# Certificate of Appropriateness

117 W. VINE ST.

PTS ID 31169 COA, retaining wall and wood privacy fence on east lot line

**Property** 117 W. VINE ST.  
**Description of work** Parking lot east of Schlitz Cooper lofts  
**Date issued** 11/8/2006 PTS ID 31169 COA - Parking Lot

4 SECTION AT EAST PERIMETER FENCE  
3/8" x 1'-0"

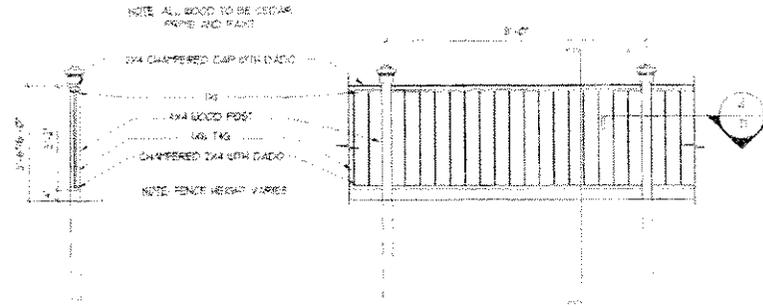
Fence will be clear-coated upon completion to protect it from the weather and so it will not discolor. All work will be done according to attached drawings. Fence will be made of cedar.

2 PARTIAL EAST ELEVATION W/ SECTION, TYP.  
3/8" x 1'-0"

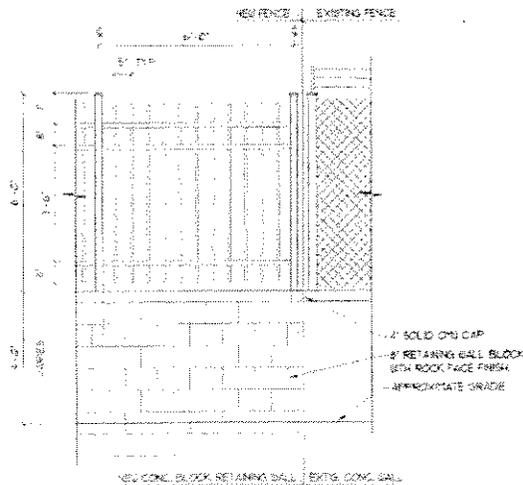
Brick masonry must be Cream City Brick that will be chemically cleaned. Joints will not exceed 3/8" in width. A concave or slightly raked joint will be used.
